THE CRANBROOK PLAN

Examination
Gypsy and Traveller Provision
Question AQ22-26

JBB8781
The Cranbrook Plan

30 September 2020

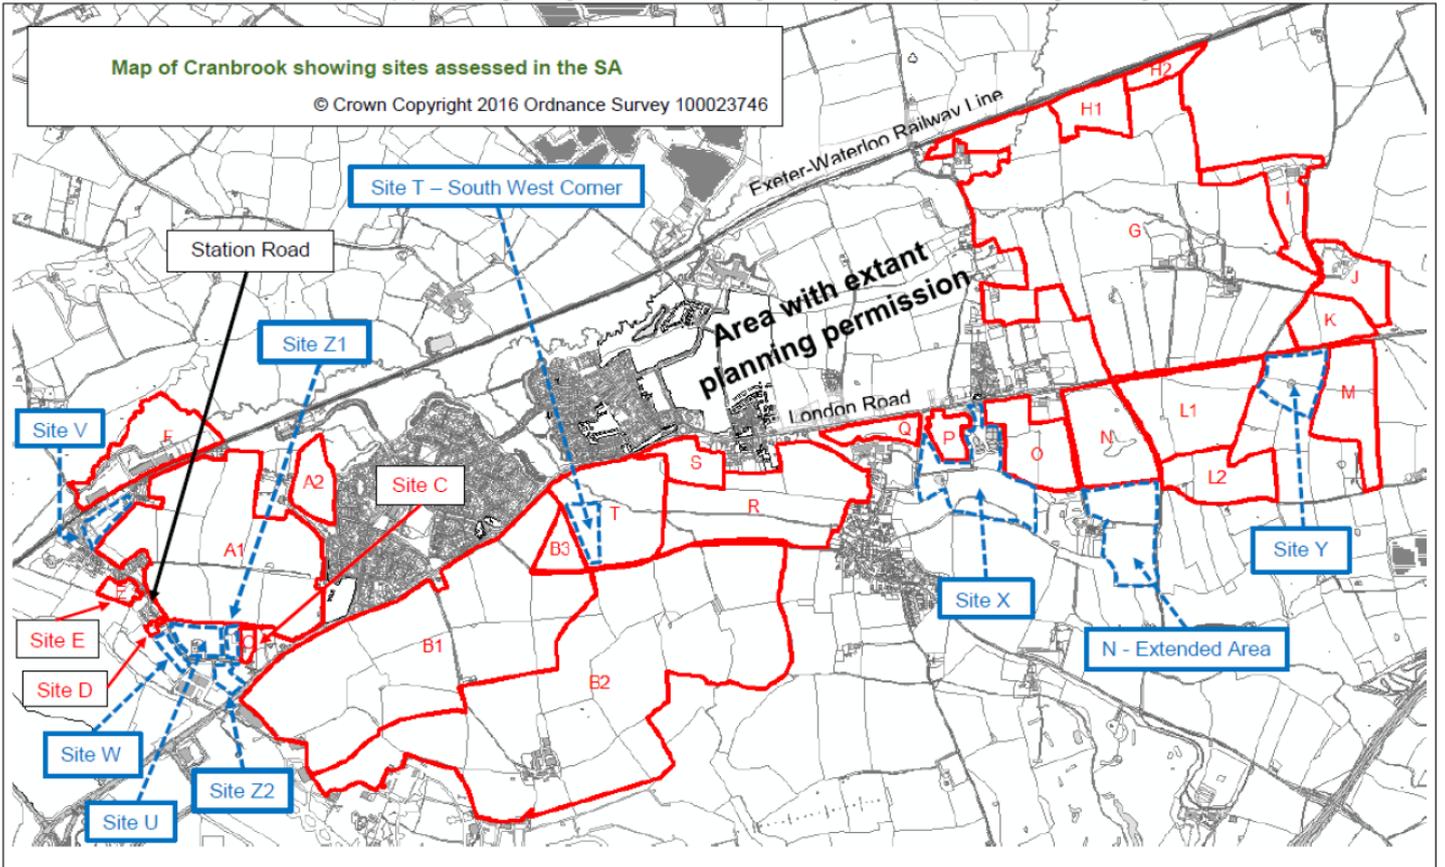
AQ25. Fig1 in the Land Budget Technical Note indicates additional SANGS land shown pink but makes other alterations including the omission of the sports pitches it also incorporates white land between the additional SANGS allocation and that formerly indicated for sports pitches and similarly land around the allocation for the Gypsy and Traveller allocation. Please clarify the anomalies. [Council]
